**Final Written Submission
Agnico Eagle Mines Limited
New Water Licence Whale Tail Project
2AM-WTP and Water Licence Amendment for
Meadowbank Project 2AM-MEA1525**

**Indigenous and Northern Affairs Canada
Nunavut Water Board Submission**

**Submitted to:
Nunavut Water Board**

August 14, 2017

Figure 1 – WRSF Seepage with 2 m Active Thaw Depth (without treatment)

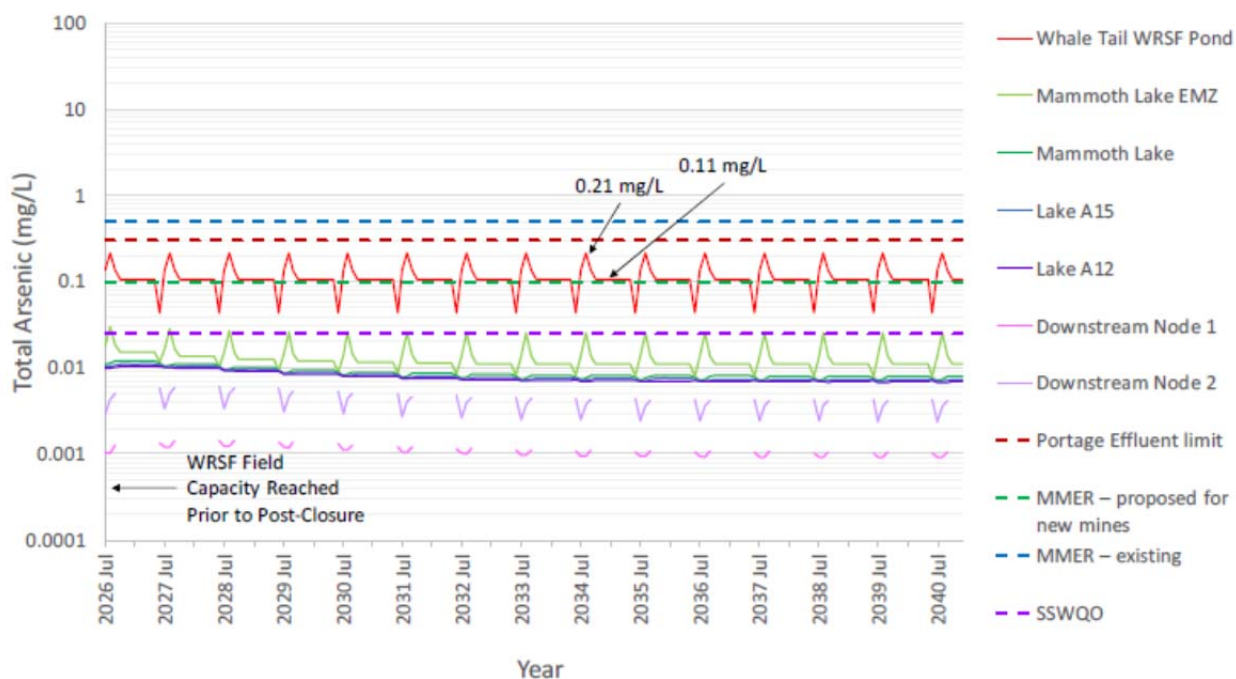
<p>loads in the WRSF seepage. INAC therefore requested that the modelling be revised to evaluate seepage from a 4 m active thaw depth.² The Applicant's findings associated with this additional analysis are presented in the above-noted sensitivity analysis.</p> <p>As shown Figures 1 and 2, the maximum seasonal arsenic concentrations for the 4 m thaw depth are approximately double the predicted concentrations for the 2 m depth (0.35 mg/L as compared to 0.21 mg/L). This illustrates the general relationship between the depth of the active zone and arsenic concentrations in seepage. It is important to note that arsenic concentrations in seepage from a 4 m thaw depth are 3.5 times greater than the Applicant's proposed operational Effluent Quality Criterion (EQC) for arsenic of 0.1 mg/L. While operational EQC are not intended for application to closed facilities, this emphasizes the potential need for seepage management/treatment during the post-closure phase of the project. There is also a need for clearly defined WRSF closure criteria that address seepage quality.</p> <p>The modeled increased arsenic concentrations in seepage attributable to the thicker cover could result in higher arsenic loadings to the downstream receiving environment. Nonetheless, as shown in Figure 3, the sensitivity analysis predicted that arsenic concentrations in Mammoth Lake (i.e., the immediate downstream receiver) would remain below the SSWQO, even without treatment. This conclusion applies only to the spatial <u>average</u> of arsenic concentrations in the receivers; localized exceedances of the SSWQO within Mammoth Lake will exist until sufficient mixing/dilution has occurred. While the Applicant has indicated that any such exceedances will be limited to a proposed 100 m Effective Mixing Zone (EMZ), this conclusion is based on simplified mass balance assumptions, not detailed hydrodynamic modelling. As a result, there is insufficient information to determine the spatial extent of potential adverse impacts within Mammoth Lake that could result from the WRSF seepage. With regard to the risks associated with seepage, it is important to note that the length of time required for WRSF seepage to reach a state of equilibrium is unknown. This is attributable to a variety of factors, including but not limited to the number of years needed for the WRSF to reach its field capacity (i.e., moisture storage limits). While the Applicant's modelling predicts that the field capacity will be reached during or soon after closure (see Figures 1 and 2), INAC is of the view that seepage quality may not reach equilibrium until well into the post-closure phase. As a result, there is a potential that the WRSF will not start to generate unacceptable seepage quality until several years after closure has been implemented. At that stage, there will be relatively few mitigations that could be implemented to control the impacts associated</p>

Recommendation/Request	<p>a. WRSF Seepage Management: To manage the low probability but high consequent scenario of water quality from the WRSF being above set criteria as proposed by the applicant at closure and post closure, INAC recommends i) that the waste rock management plan be revised and updated to include more waste rock sampling to provide improved confidence that cover contamination is not occurring, and ii) the monitoring plan for the WRSF and associated attenuation pond be updated to include WRSF seepage monitoring criteria that must be met before AEM considers breaching the dike/dam of the associated attenuation pond. This criteria in addition to specifying acceptable water quality, would include required number of acceptable sampling events that would be necessary to confirm that stable seepage had been attained and over a specified time frame (this may also include increased sampling events during certain times of year e.g., spring freshet).</p> <p>b. Conduct Hydrodynamic Modelling of Seepage Discharges: INAC recommends that the Applicant conduct detailed hydrodynamic modelling to evaluate the mixing of WRSF seepage discharges to Mammoth Lake during the post-closure phase of the project. The modelling should evaluate a range of potential seepage discharge scenarios (clean/contaminated cover, increased active zone depth, etc.). Any results from the modelling should be incorporated into the appropriate monitoring plan for review and approval.</p> <p>c. Incremental Security: Due to a number of uncertainties surrounding water quality INAC's security estimate has taken into account the potential for long-term treatment. If in the future,</p>

Figure 4 – WRSF Seepage with 2% Cover Contamination (4 m active depth, without treatment)

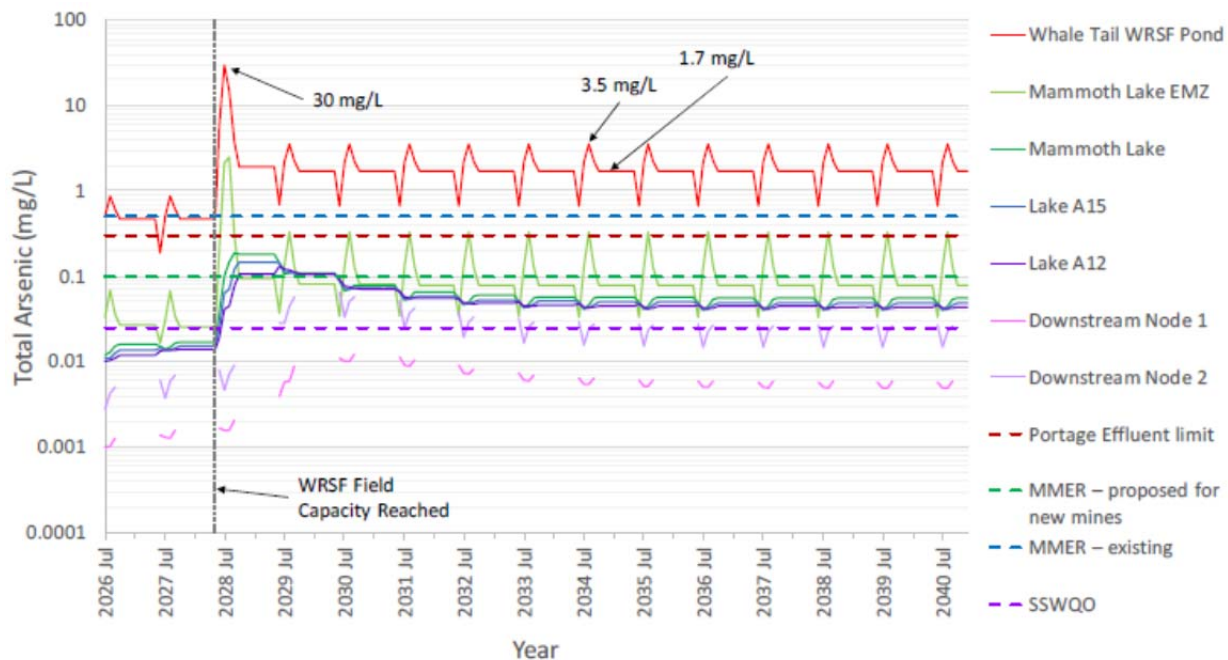
Given the magnitude of predicted arsenic concentrations, the probability of cover contamination warrants consideration. Towards this end, the Applicant's sensitivity analysis included a qualitative discussion that addresses the likelihood of cover contamination. The discussion focuses on the waste rock management practices that will be used to minimize mixing of potentially problematic waste rock within the otherwise clean cover. The Applicant stated they are confident these practices will essentially eliminate the risk of cover contamination and that the probability of seepage having the elevated arsenic concentrations predicted in Figures 4 to 7 was classified as low.

While INAC does agree that there is a low risk of contamination, some degree of contamination is likely. While it is possible that the 2% and 5% scenarios represent the upper bound of potential cover contamination, the elevated arsenic concentrations associated with those scenarios suggest that lower levels of cover contamination (e.g., 1% or 0.5%) would also result in seepage with highly elevated arsenic concentrations.

Figure 6 – Downstream arsenic concentrations with 2% Cover Contamination (4m active depth, without treatment)

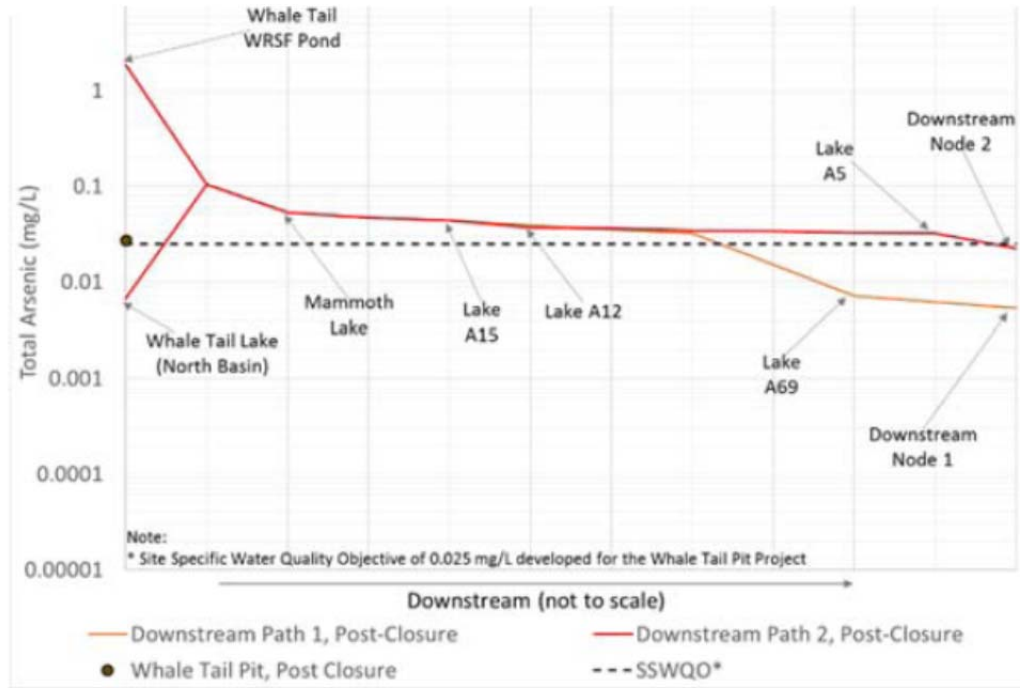
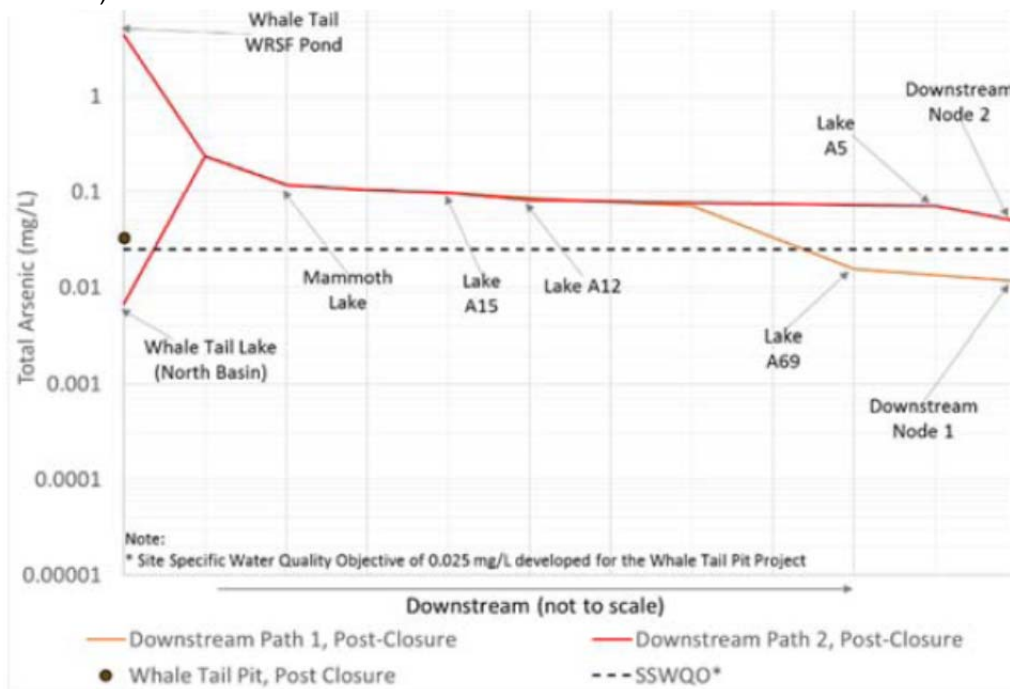
As shown in Figures 6 and 7, seepage from the 2% and 5% cover contamination scenarios is predicted to result in arsenic concentrations that are above the SSWQO in multiple downstream receivers, if discharged without treatment. Concentrations would be particularly elevated in Mammoth Lake but other downstream lakes would also witness elevated arsenic levels.

Figure 8 – Arsenic Concentrations in the Pit and North Whale Tail Lake, with and without Diffusion from the Pit Walls, for the Base Case Scenario (i.e., without north wall push back)

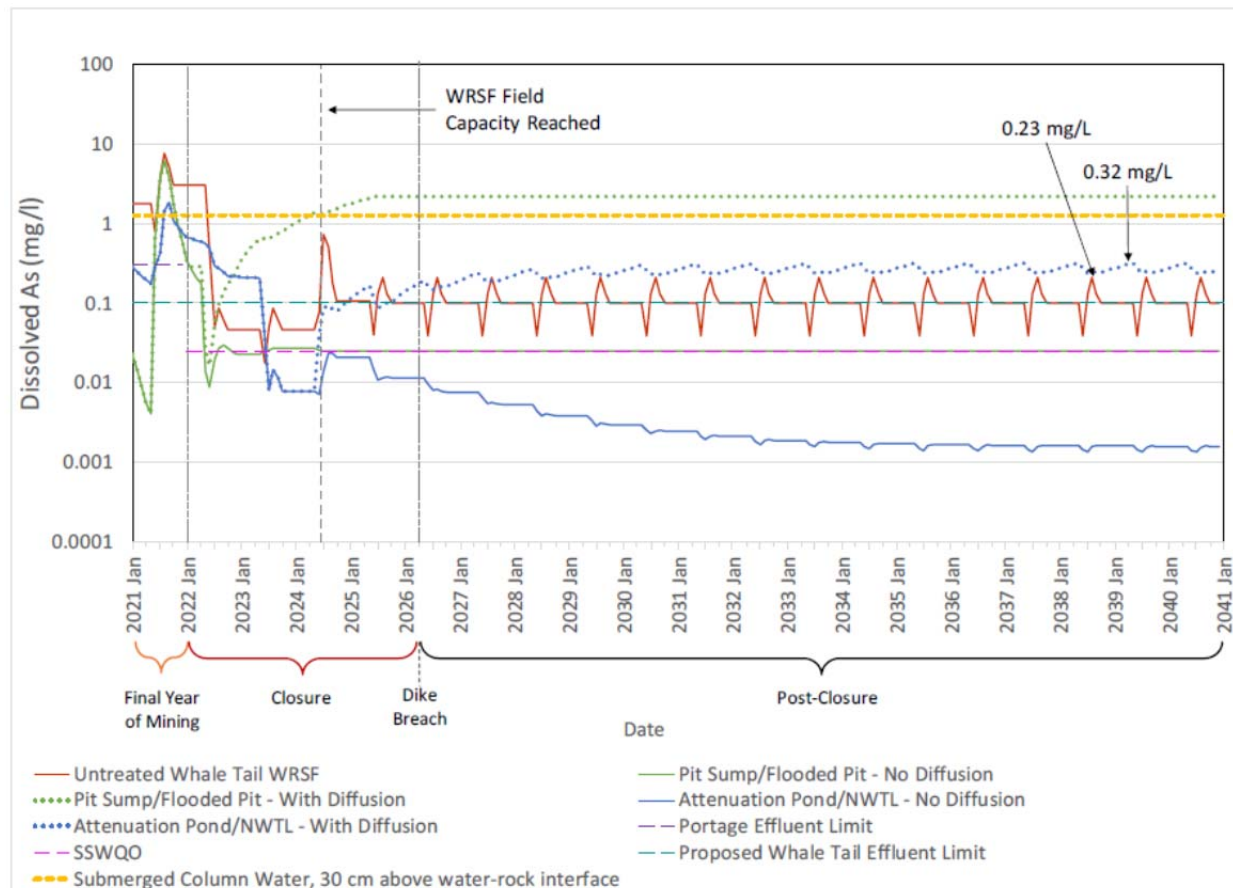
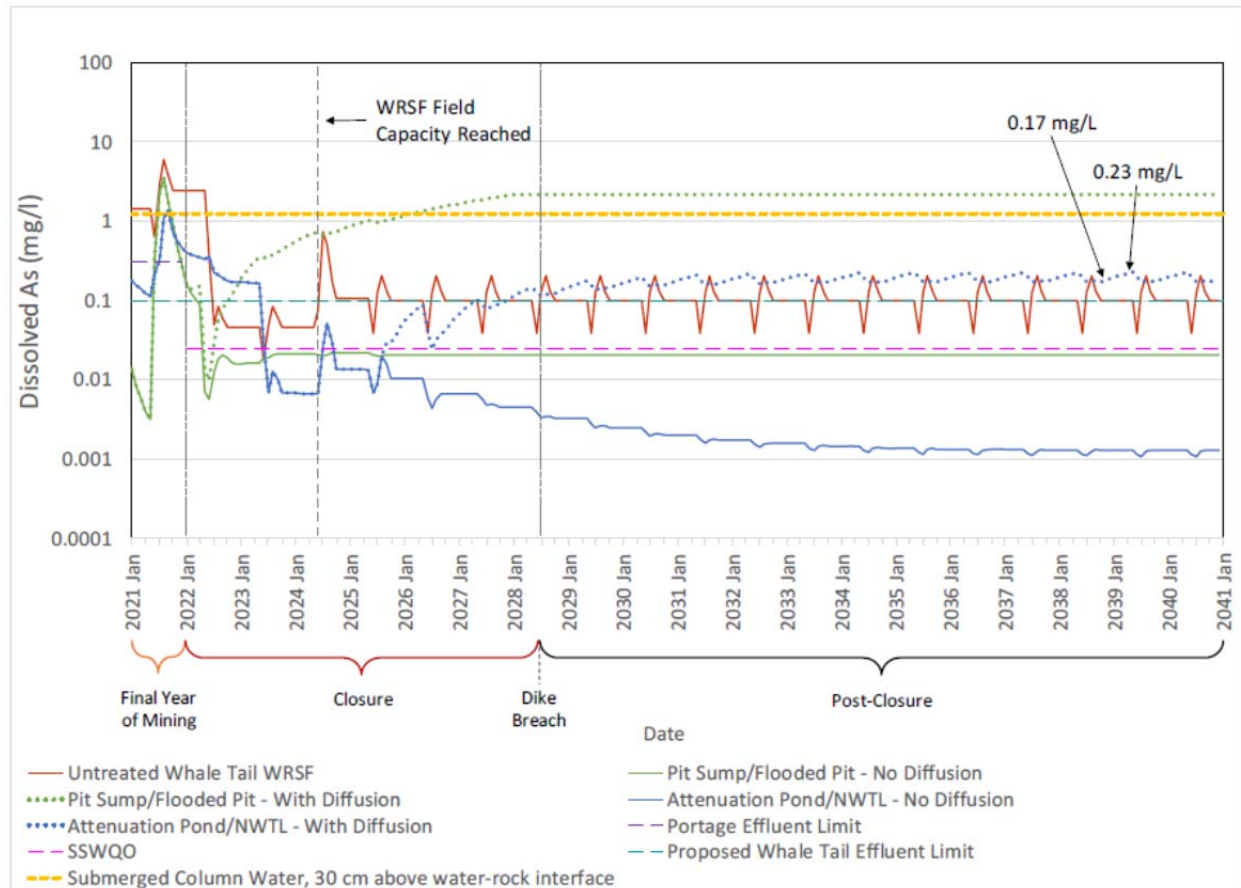
with the hydrogeological and hydrogeochemical properties in the vicinity of the pit. Further, based on the elevated arsenic concentrations that were predicted for the diffusion scenarios, it is reasonable to assume that partial diffusion would also result in poor water quality in some situations.

INAC notes that, a definitive answer regarding diffusion may not become available until the pit and lake have been fully back-flooded and the water table has been restored to pre-mining levels.⁴ Prior to that point, there will continue to be a uncertainty regarding the hydrogeological conditions and potential diffusion during the post-closure phase.

Recommendation/Request	<ol style="list-style-type: none">a. Perform Hydrogeological Characterization Studies: INAC recommends that additional hydrogeological characterization studies be performed to address uncertainties and to validate the Applicant's current conclusions regarding hydraulic gradients and arsenic diffusion potential. INAC has looked at the proposed schedule of activities at Whale Tail and interprets there to be enough time during the 2018 field season to undertake these studies prior to the dewatering of Whale Tail Lake and the development of the pit. The studies will serve as an important pre-development baseline and will help to address current uncertainties regarding water quality in the back-flooded pit/lake.b. Evaluate Meromixis: If the additional hydrogeological characterization studies indicate that future metals levels are of potential concern, then the importance of establishing a stable stratified pit would be amplified. In that case, the Applicant should undertake a detailed quantitative analysis confirming that stable meromictic conditions will occur within the flooded pit. The analysis should include modelling that demonstrates meromixis will remain stable under a range of conditions (groundwater discharge, high wind, pit wall failure, etc.).c. Monitoring Plan: To supplement the monitoring plans already submitted by the Applicant, INAC recommends that a revised and updated monitoring plan for the flooded pit of the Whale Tail Project be submitted to the NWB for review and approval prior to construction. The updated plan would include specified
